Addendum Number 3

Lake Peachtree Spillway Replacement Project

August 4, 2017

SCALE: 3'8" x 1'0"

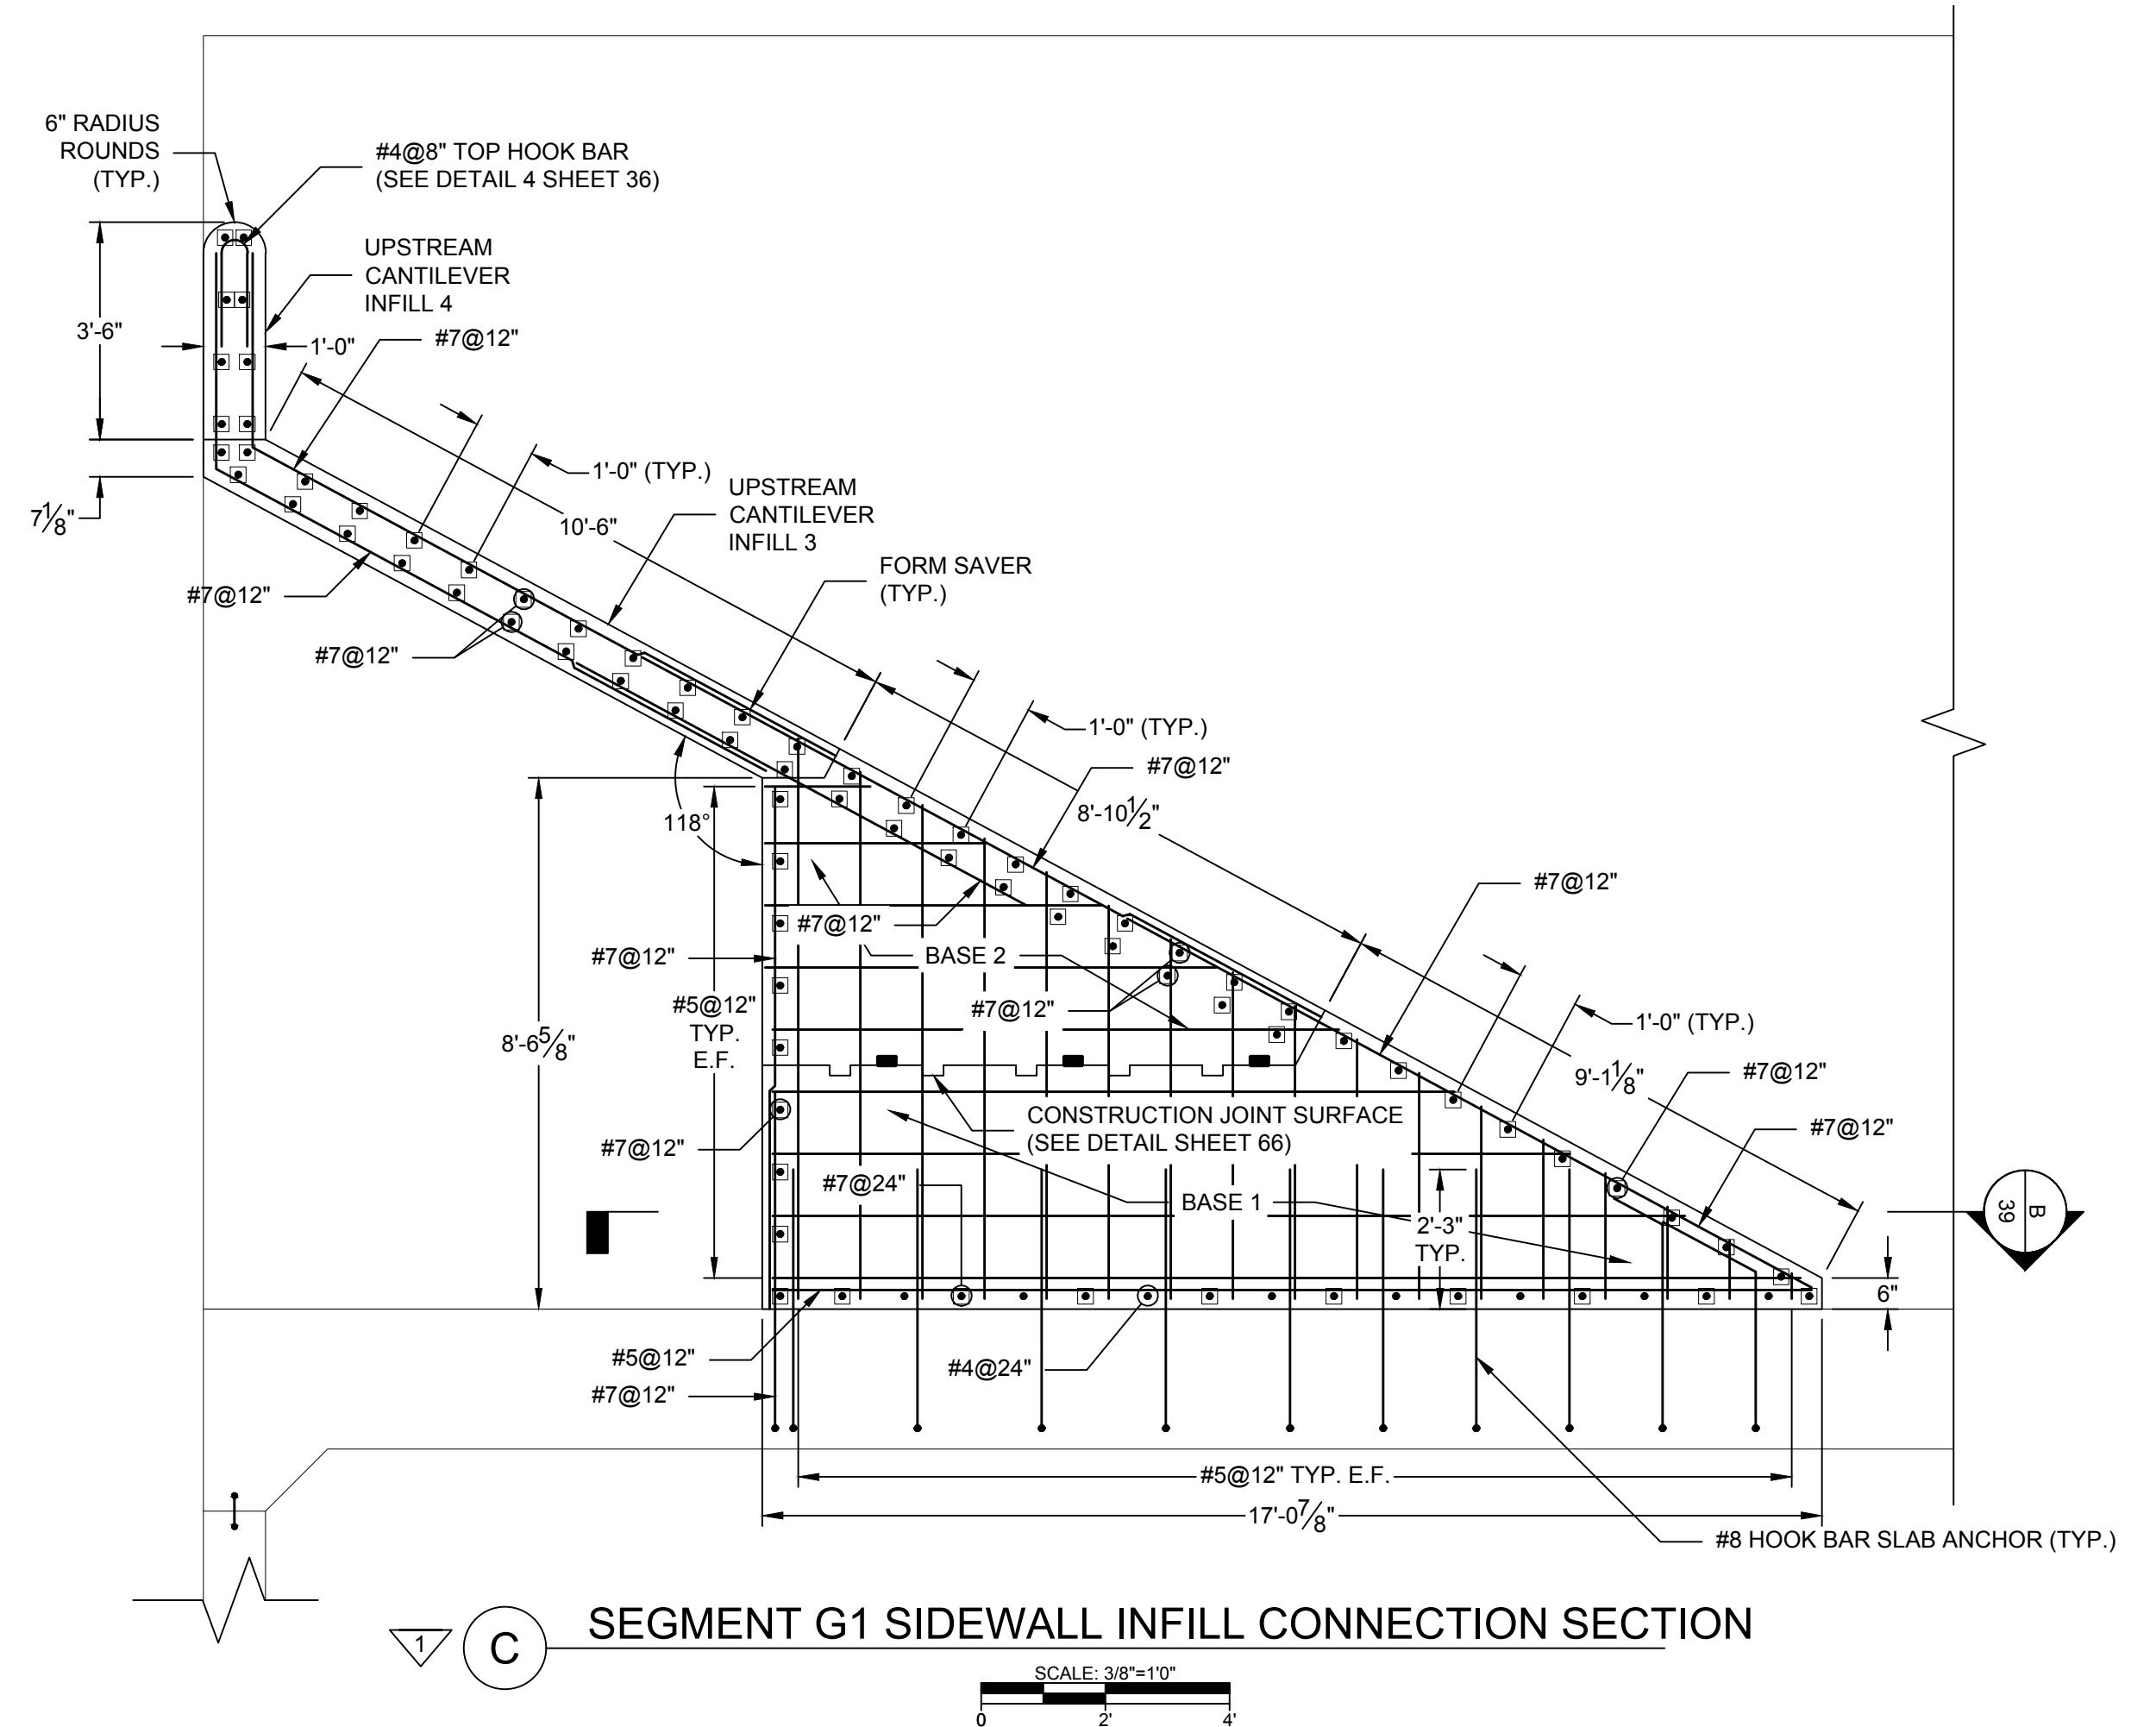
Note: The upstream ramp support walls (Sheets 37, 48, 53) were revised to include a 12-inch radius to improve hydraulic efficiency on the upstream ends of those walls.

PROJECT: 16C17043.00
DATE: 07/10/2017
SHEET 43 OF 66

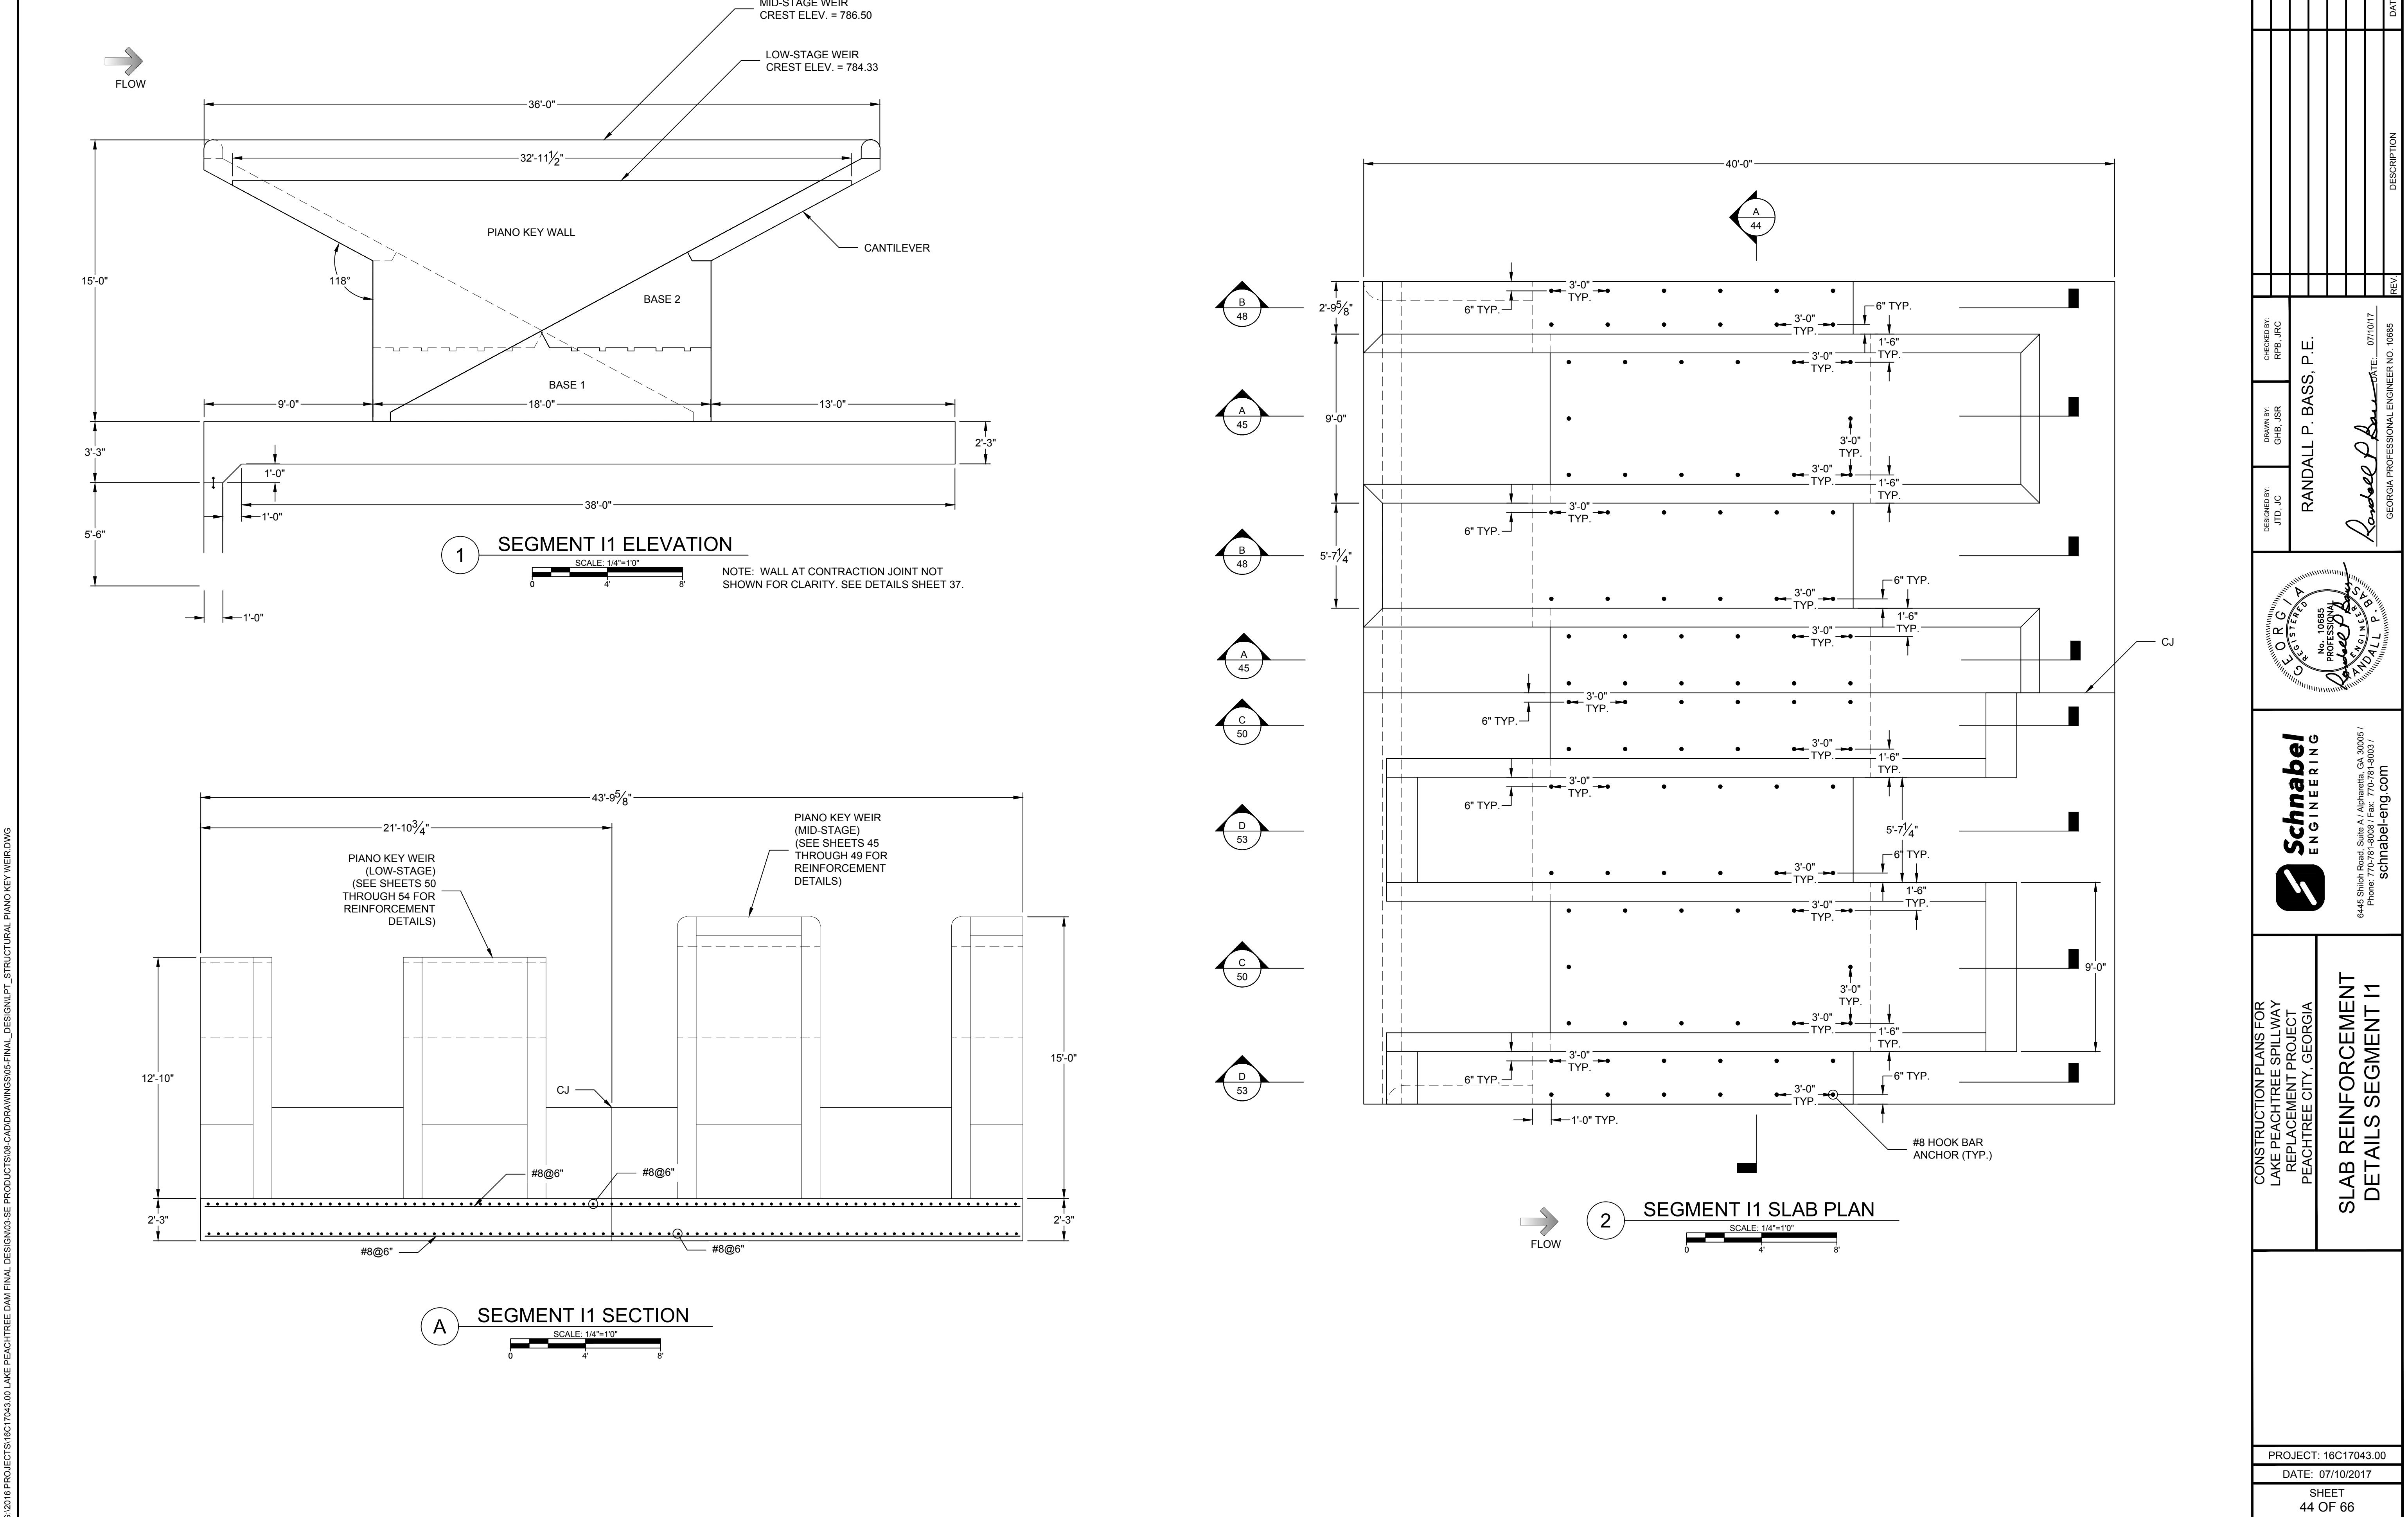
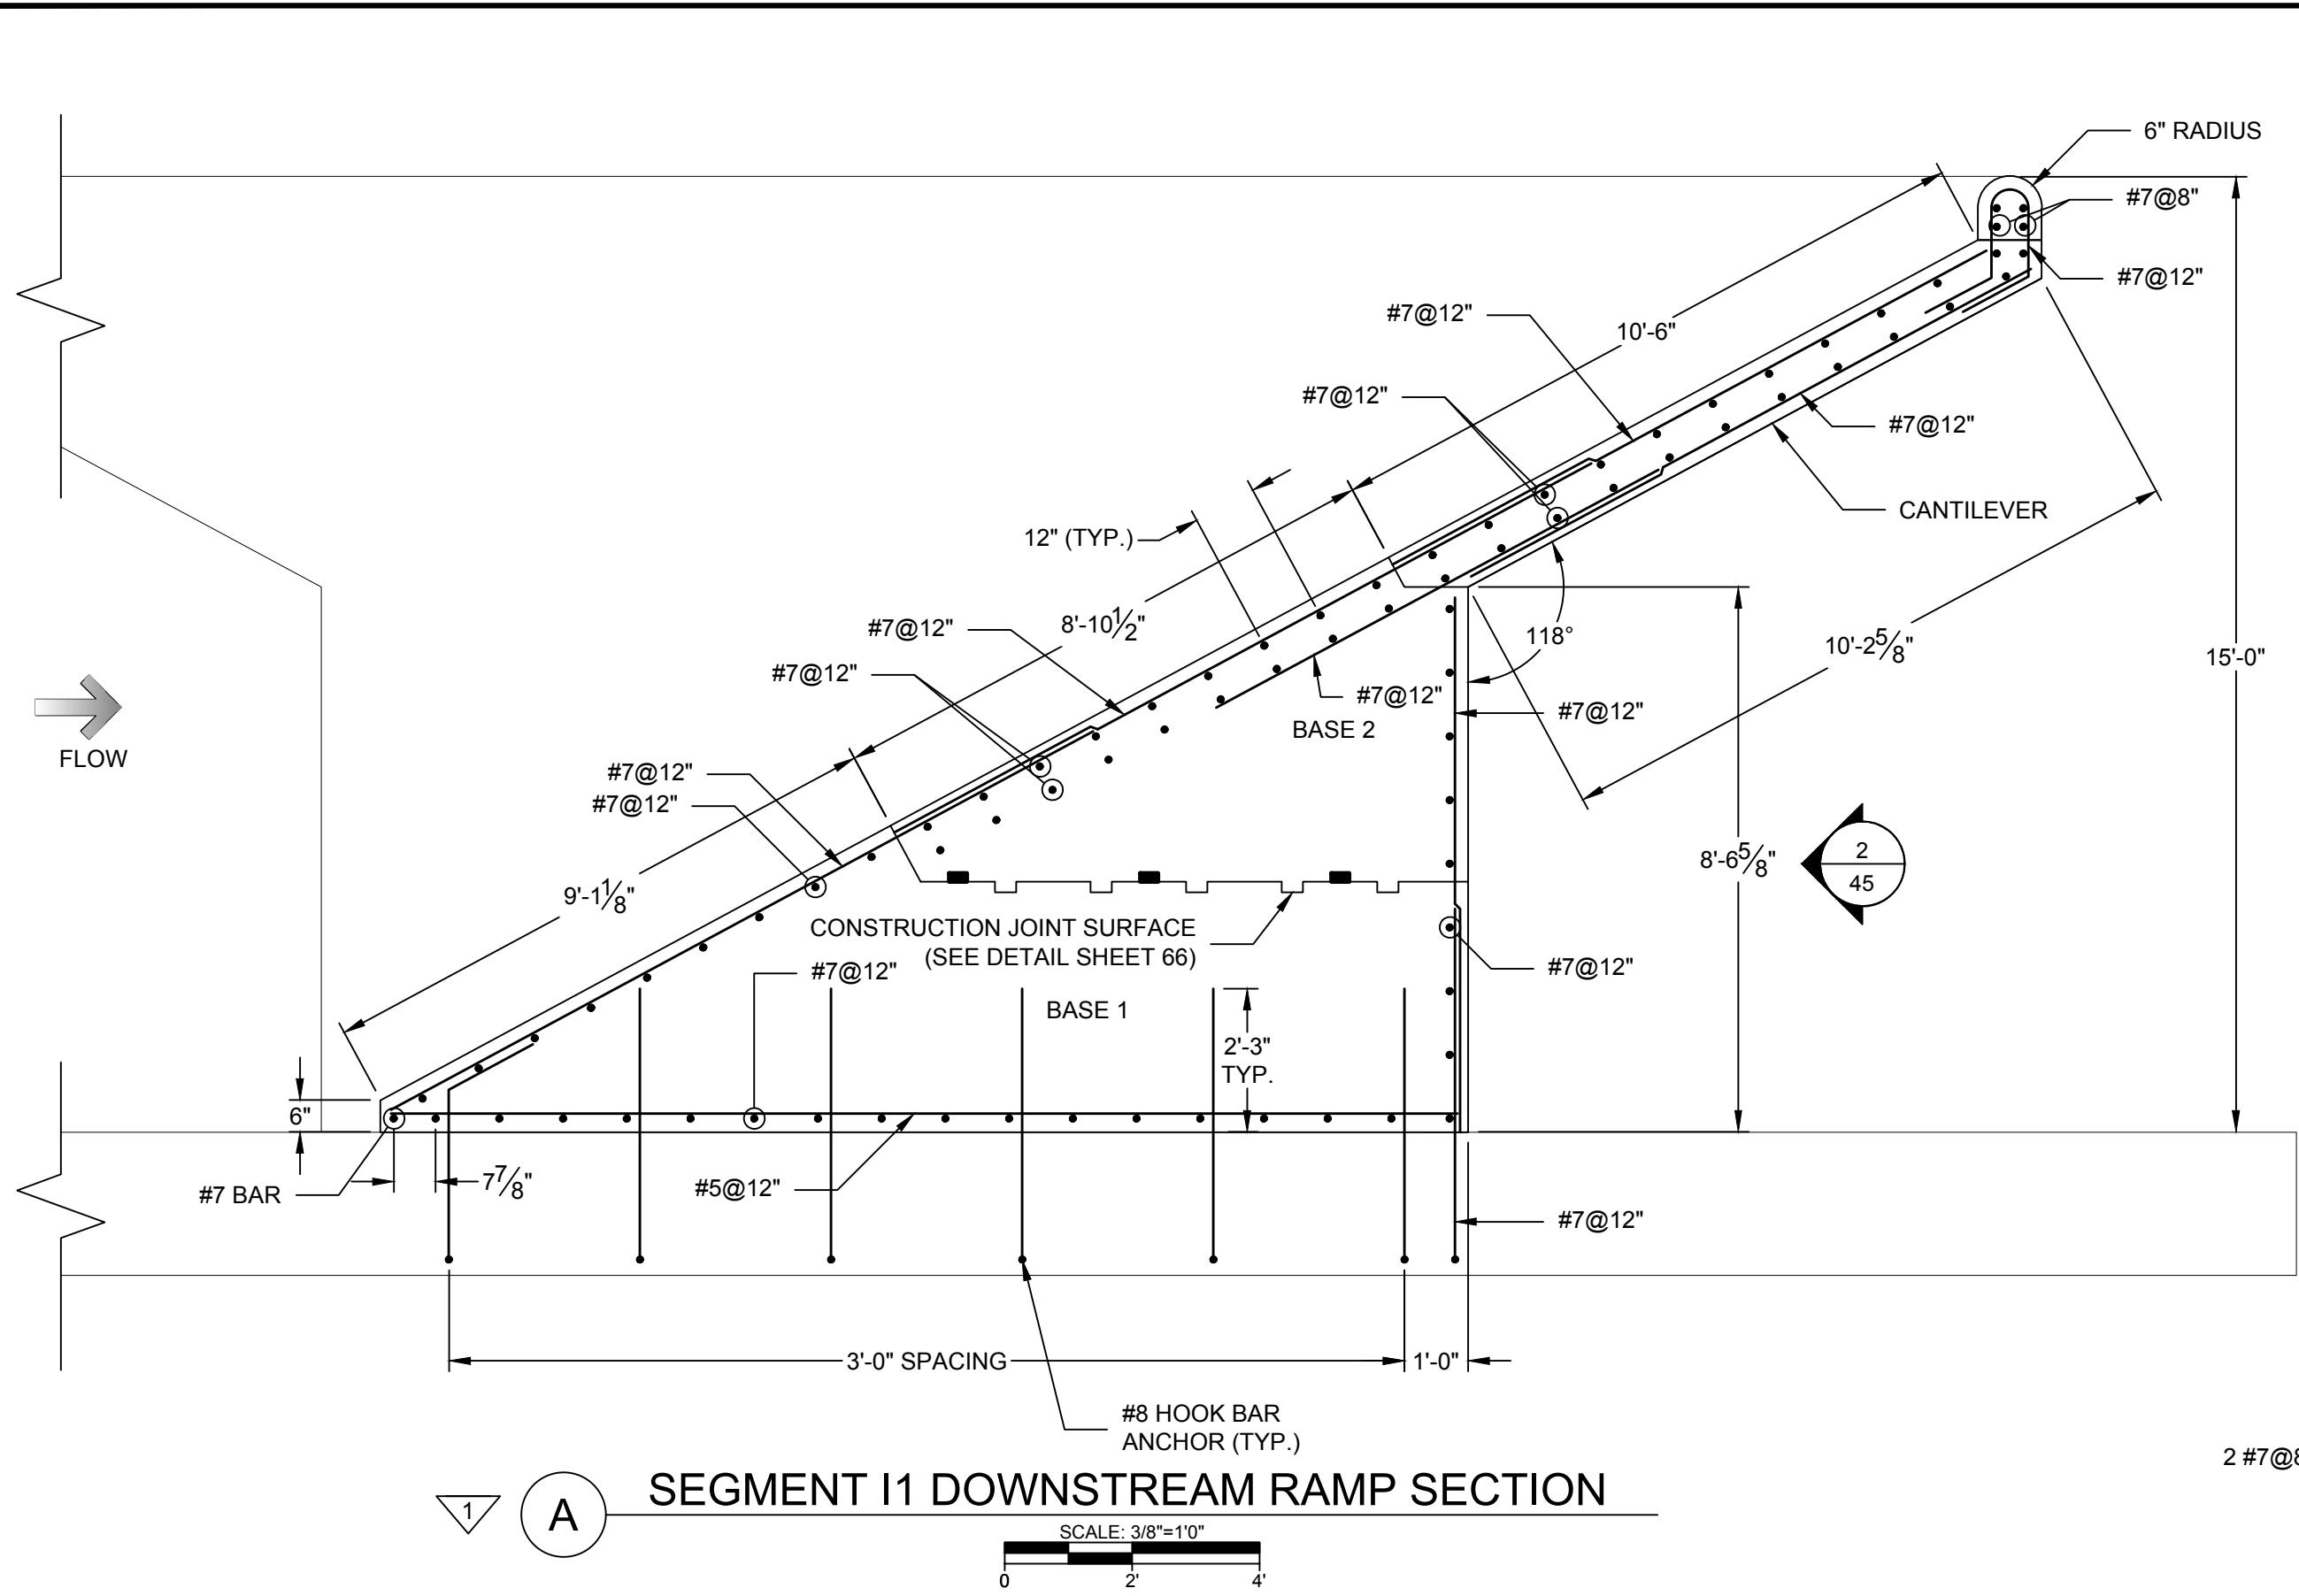
- a. The dimensions shown on the section view are correct. An updated sheet depicting the bridge dimensions is appended for your convenience.
5. (Reference: Plan Sheets 33, 40, 43, 44) Please provide depths for the upper cut-off walls for slab sections G1, G2, H1, H2 and I1. Also provide rebar configurations for these walls.

- a. The depth of the upstream cutoff walls is 6 and one-half feet below the slab subgrade. The reinforcing steel is shown on the revised sheets.
6. Please confirm that Bid Item 16c, "Slab Concrete" includes construction of slabs A1 through I1, all inlet/outlet wing wall slabs and all cut-off walls beneath these slabs.
